141 FERC ¶ 61,236
UNITED STATES OF AMERICA
FEDERAL ENERGY REGULATORY COMMISSION

[Docket Nos. RM12-6-000 and RM12-7-000; Order No. 773]

Revisions to Electric Reliability Organization Definition of Bulk Electric System and
Rules of Procedure

ORDER NO. 773

Figure 1
Two Radial Systems Eligible for Exclusion E1

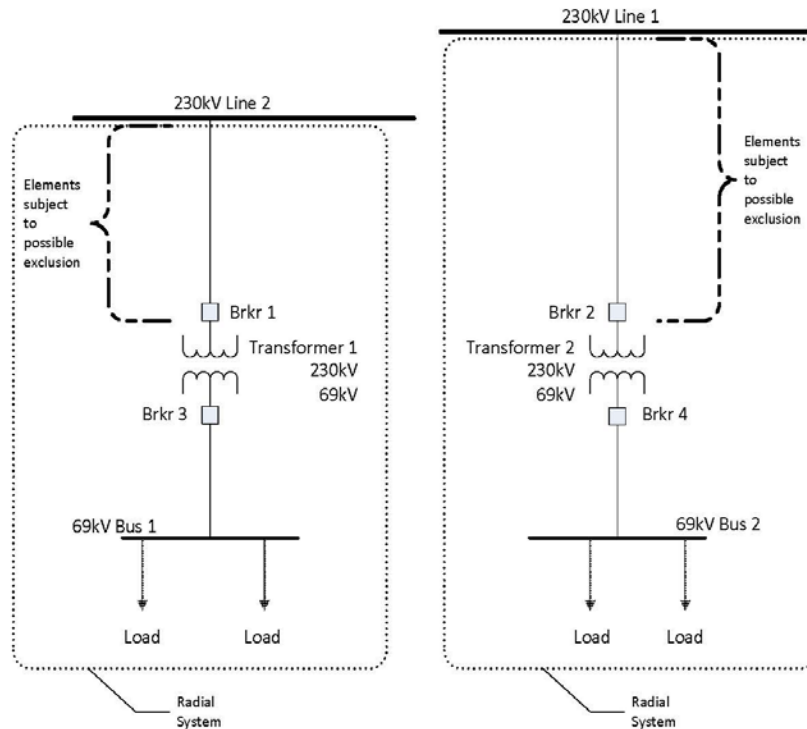
135. NERC and other commenters state that both radial systems depicted in figure 1 would be subject to exclusion E1(a) because they each only serve load.¹²⁶ ELCON agrees with NERC adding that these types of radial systems pose no reliability risk to the interconnected transmission network if the system is lost due to a fault condition. Similarly, SoCal Edison states that the figure 1 facilities would either be excluded or not

part of the bulk electric system. SoCal Edison asserts that, because transformers 1 and 2 each have secondary voltages that are less than 100 kV, they do not meet the inclusion II requirements and, thus, are not included in the bulk electric system. In other words, SoCal Edison believes exclusion E1 should exclude all radial facilities that are greater than 100 kV up to the point where “the system is no longer radial, as indicated in figure 1 by the brackets where the 230 kV lines meet [lines 1 and 2].”¹²⁷ APPA believes that all the scenarios described by the Commission could create reliability concerns “if taken in isolation and operated in a certain matter” and believes that the exception process can capture configurations that pose a significant risk to the reliable operation of the interconnected transmission network. Idaho Power maintains that it is inappropriate to apply exclusion E1 for 230 kV elements in the scenarios if the breakers are part of the protection scheme for a three terminal 230 kV line. Idaho Power adds that if either breaker only opens for transformer protection, the exclusion would be applicable.

136. Anaheim agrees that the radials shown in figure 1 should be excluded and requests clarification that the associated bus work and protection system equipment installed on those radial lines are also excluded. Anaheim advocates that the exclusion should also apply to protection system equipment on the excluded facilities that provide backup protection for devices that are part of the bulk electric system, i.e. lines 1 and 2 in figure 1.

140. The Commission agrees with NERC that the radial systems shown in figure 1 meet the definition of “radial system” in exclusion E1. This configuration would result in the 230 kV lines between transformers 1 and 2 to the two 230 kV lines, respectfully, being excluded from the bulk electric system. The Commission agrees with NERC and other commenters that both radial systems depicted in figure 1 would be subject to exclusion E1 condition (a) because they each only serve load.

Figure 2
Networked Configuration w/115 kV Loop

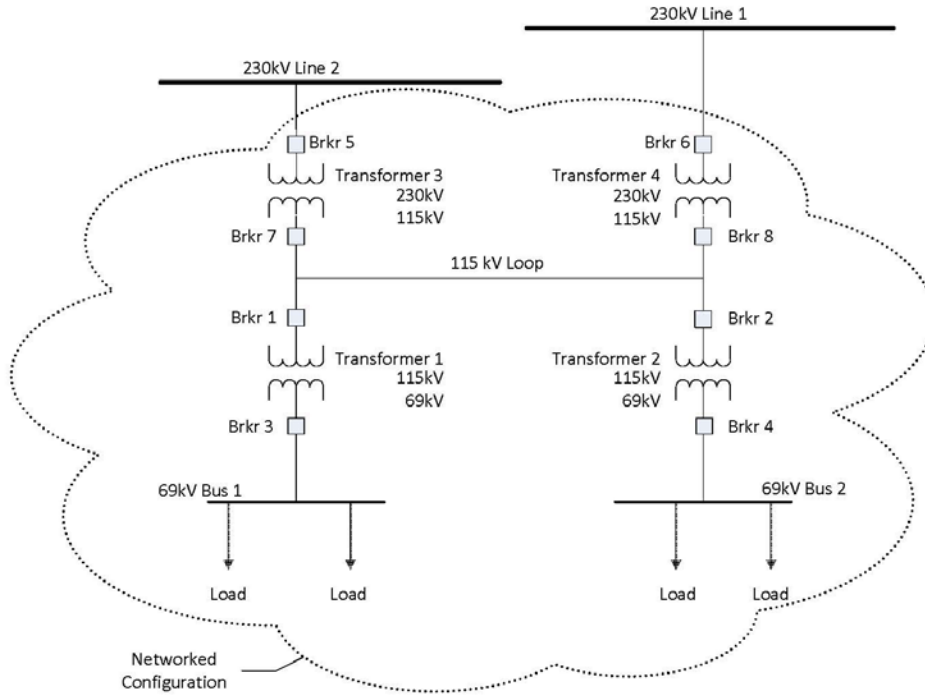
144. In the NOPR, the Commission requested comment on the scenario shown in figure 2 which shows a 115 kV loop, with the configuration emanating from two points of connection of 100 kV or higher. Specifically, the Commission requested comment on whether “the 115 kV and 230 kV elements above Transformers 1 and 2 to the points of connection to the two 230 kV lines would be excluded from the bulk electric system pursuant to exclusion E1.”¹³⁰ The Commission asked for comment on whether it is more appropriate to analyze figure 2 pursuant to the “local network” exclusion E3 and, if so, what if any elements operated at or above 100 kV would be excluded pursuant to exclusion E3.

145. NERC states that figure 2 is a non-radial loop on the 115 kV system. According to NERC, the 115 kV elements above transformers 1 and 2 to the point of interconnection with lines 1 and 2 would not be eligible for exclusion E1 because they do not emanate from a single point of connection. NERC also states that it would be appropriate to evaluate figure 2 under exclusion E3 as a potential local network.¹³¹ For such a

146. Likewise, Idaho Power, ITC Companies, and National Grid contend that the figure 2 configuration should be included in the bulk electric system. Southern Companies believe exclusion E1 may apply from the breakers down and that the configuration may belong to exclusion E3. AEP assumes that each of the facilities below the 115 kV loop shown in figure 2, and including breaker 1 and breaker 2, are radial and excluded pursuant to exclusion E1. According to AEP, the facilities above breakers 1 and 2 may be excluded pursuant to exclusion E3 depending on the circumstances.¹³³

147. Valero states that the figure 2 configuration is very similar to common facilities configurations employed in many industrial facilities involving the interconnection of the industrial facility to the utility through two high voltage feeder lines that originate at different utility owned and operated substations. Valero requests that the Commission include in the final rule an additional exclusion that would “categorically exclude from the [bulk electric system] any on-site high voltage switchyard facilities (less than 300 kV) owned by the industrial end-user where the predominant function of the facilities is to

distribute electricity in an inward direction to the end-user's load.”¹³⁴ WPPC argues that figure 2 shows both radial and network systems and that the system from the 115 kV loop upwards would be assessed under exclusion E3 and below that point would be assessed by exclusion E1.

148. The Commission affirms NERC's statement that figure 2 is a non-radial loop and thus would not be eligible for exclusion E1 because it does not emanate from a single point of connection. The Commission agrees with commenters that the elements below the 115 kV loop should be assessed as two separate radial systems pursuant to exclusion E1. The remaining elements (the 115 kV loop, transformers 3 and 4 and the 230 kV tie lines above the transformers to the two 230 lines 1 and 2) should be assessed pursuant to exclusion E3 and if the configuration meets the criteria of exclusion E3, the elements could be excluded.

Figure 3
Networked Configuration w/69 kV Loop

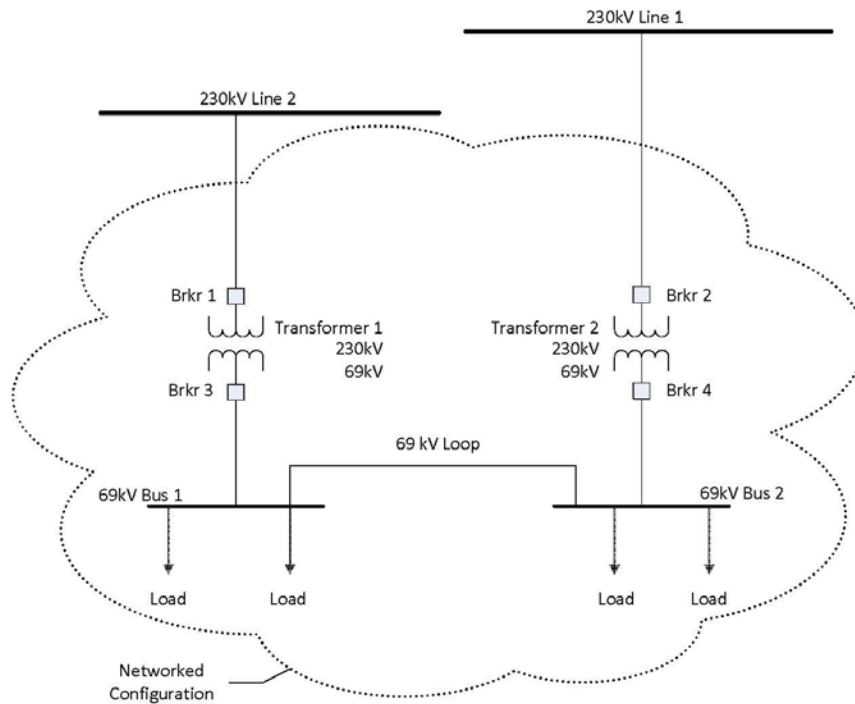
150. In the NOPR, the Commission agreed with NERC's proposal that radial systems only serving load and emanating from a single point of connection of 100 kV or higher should be excluded from the bulk electric system. However, the Commission expressed concern "that the exclusion could allow elements operating at 100 kV or higher in a configuration that emanates from two or more points of connection "to be deemed "radial" even though the configuration remains contiguous through elements that are operated below 100 kV."¹³⁵ Figure 3 in the NOPR illustrated this concern, and the Commission asked for comment on how to evaluate the configuration relative to the radial system definition. The Commission also requested comment on the appropriateness of examining elements below 100 kV to determine if the configuration meets exclusion E1, i.e., whether figure 3 depicts "a system emanating from two points of connection at 230 kV and, therefore, the 230 kV elements above the transformers to the points of connection to the two 230 kV lines would not be eligible for the exclusion E1 notwithstanding the connection below 100 kV."¹³⁶

151. NERC disagrees with the Commission's characterization of figure 3 in the NOPR. NERC states that figure 3 does not depict a configuration with two points of 100 kV or higher or a system emanating from two points of connection at 230 kV. According to NERC, except for lines 1 and 2, all the other elements depicted in figure 3 are excluded from the bulk electric system. NERC explains that the elements between line 1 and transformer 2 and from line 2 to transformer 1 are excluded by exclusion E1(a) because "each separate set of [e]lements [described above] is contiguous and emanate from a

153. Exelon agrees with NERC and explains that it has many connections similar to the one shown in figure 3 and provides a specific example where a 138 kV substation is fed by two radially connected 138 kV lines which in turn are connected through 40 MVA transformers to a 12 kV bus section. Exelon states that in its example the 40 MVA transformers cross bus sections so that if one of the 138 kV lines is out of service, each side of the 12 kV bus retains service. Exelon believes that due to the high impedance of the transformers, little energy flows between the buses in Exelon’s example.¹³⁸ Exelon

154. Other commenters believe that the figure 3 configuration may not be eligible for exclusion E1. SoCal Edison explains that the 69 kV loop is not open and therefore is a parallel path to the 230 kV system. BPA, Alameda and WREA do not view the figure 3 system as eligible for exclusion E1 because the system is networked. Idaho Power states that the 230 kV lines would be included only if there is a protection system in place for the 230 kV lines. According to Idaho Power, the elements above the transformers in figure 3 would not be excluded from the bulk electric system. Idaho Power believes this configuration should be evaluated under exclusion E3.

155. The Commission finds figure 3, which is identical to figure 5, is a networked configuration through a 69 kV loop and does not qualify for exclusion E1. The Commission also finds that, because the load in figure 3 can be served by either 230 kV line, it does not depict a “radial system.” However, the facilities below 100 kV may or may not be necessary for the operation of the interconnected transmission network, and this decision can be made case-by-case in the exception process. In other words, such facilities below 100 kV depicted in figure 3 would be excluded under the general threshold of the core definition unless found on a case-specific basis as necessary for the reliable operation of the interconnected transmission network. Thus, the Commission, while disagreeing with NERC’s interpretation, does not propose to include the below 100 kV elements in figure 3 in the bulk electric system, unless determined otherwise in

the exception process. Further, as we discuss below in connection with exclusion E3 and figure 5, while we find that the configuration shown in figures 3 and 5 would not be eligible for exclusion E1, we believe that such configurations should be eligible for exclusion E3 for local networks. However, exclusion E3 as written requires the candidate local network to be contiguous and above 100 kV, thus, the exclusion E3 language as written does not allow for figures 3 and 5 to be eligible for the local network exclusion because they are not contiguous *and* include facilities that are not above 100 kV. Therefore, we direct NERC to modify exclusion E3 to remove the 100 kV minimum operating voltage in the local network definition. This modification will enable configurations similar to figures 3 and 5 to be assessed for the local network exclusion. The Commission believes this modification, together with satisfying the criteria outlined in exclusion E3, will appropriately exclude local network configurations that are not necessary to the reliable operation of the interconnected transmission network.¹³⁹

Figure 5
Networked Configuration w/69 kV Loop

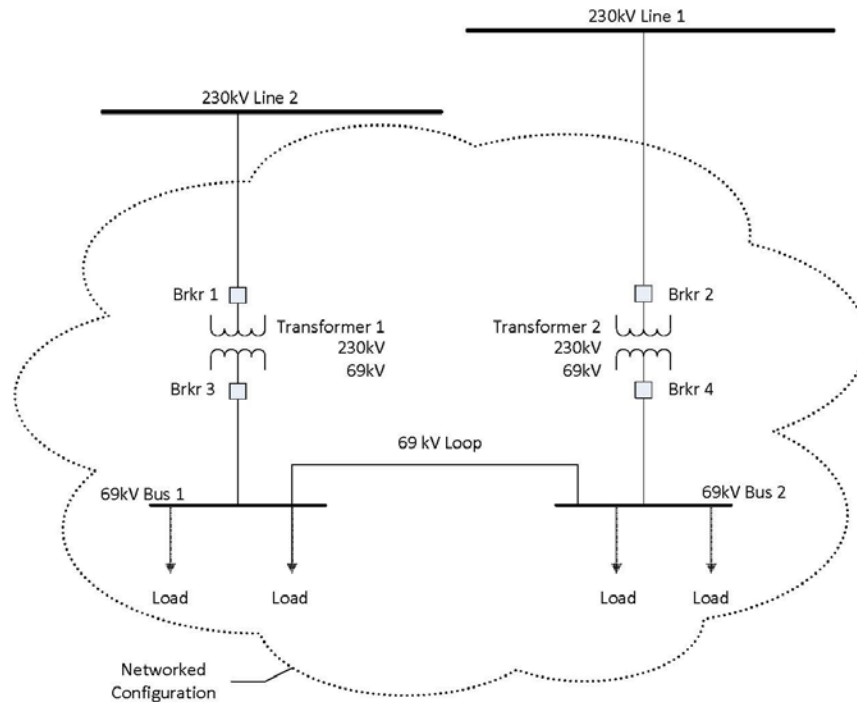
195. In the NOPR, the Commission stated that figure 5 depicts a group of elements that are contiguous through a 69 kV loop and requested comment whether the configuration in figure 5 qualifies as a local network and, in particular, whether the configuration satisfies the conditions that a local network be contiguous and operated at or above 100 kV.

196. NERC views figure 5 the same as figure 3 - as a looped system below 100 kV - that is not considered under this exclusion because the elements below 100 kV are

presumed to be not part of the bulk electric system.¹⁶⁷ NERC maintains that, if it is determined that the sub-100 kV looped system is necessary for the reliable operation of the interconnected transmission network, the exception process may be utilized to include the appropriate elements. NERC states that figure 5 depicts two separate and distinct groups of elements that each emanate from a single point of interconnection at 230 kV and only serve load. Accordingly, NERC states that 230 kV lines 1 and 2 are included in the bulk electric system with the only other included elements being the lines extending from lines 1 and 2. However, according to NERC, the elements between 230 kV line 1 and transformer 2 and between 230 kV line 2 and transformer 1 are each subject to exclusion E1(a) because each separate set of elements is contiguous and emanate from a single point of connection of 100 kV or higher. NERC asserts that the elements below the 69 kV side of transformers 1 and 2 are excluded because they are less than 100 kV. NERC explains that transformers 1 and 2 are excluded because they bridge voltages of 69 kV and 230 kV and therefore, inclusion I1 is not applicable because a transformer must have two terminals over 100 kV to qualify for inclusion I1. According to NERC, the definition should focus on looped or networked connections at 100 kV or greater because such connections, when operated below 100 kV, generally do not carry

197. Exelon states that the clear intent of the definition is that configurations such as shown in figure 5 are radial systems subject to exclusion E1 (radial systems). According to Exelon, had this not been the intent of exclusion E1, exclusion E3 would have allowed for a local network where the tie was below 100 kV to avoid a reliability gap. Exelon believes that the configuration shown in figure 5, which is identical to figure 3, does not qualify as a local network within the terms of exclusion E3 and supports NERC's view that figure 5 represents two radial systems that qualify under exclusion E1. Exelon cautions that, if the Commission determines that the systems depicted in figure 5 do not qualify under exclusion E1 because of the low voltage tie and does not qualify under exclusion E3 because the tie is at low voltage and not a 100 kV or above, such a decision would leave a gap under which a substantial number of facilities that are not part of the bulk electric system would be classified as such. Exelon states that it would have to go through the separate exception process for dozens of substations, at great cost and for no useful purpose. Exelon states that the Commission should clarify that the configuration shown in figures 3 and 5 qualifies as a radial system and is excluded pursuant to exclusion E1.

199. As discussed above, the Commission is directing a modification to exclusion E3 to better capture local networks like those depicted in figure 5. The Commission notes that Exelon believes that the configuration shown in figure 5, which is identical to figure 3, does not qualify as a local network within the terms of exclusion E3. While figures 3 and 5 are a networked configuration through a 69 kV loop, they do not qualify for the local network exclusion because exclusion E3 defines local networks as “[a] group of contiguous transmission Elements operated at or above 100 kV but less than 300 kV that distribute power to Load rather than transfer bulk-power across the interconnected system.” The configuration in figure 5 includes elements that are below 100 kV, and does not have contiguous elements operating at or above 100 kV but less than 300 kV. As noted above, while the Commission finds that these configurations should not be eligible for exclusion E1, we believe that they should be eligible for the local network exclusion. Therefore, we direct NERC to modify exclusion E3 to remove the 100 kV minimum operating voltage in the local network definition. Within 30 days of the effective date of this Final Rule, we direct NERC to submit a schedule outlining how and when it will make the modification to the definition.
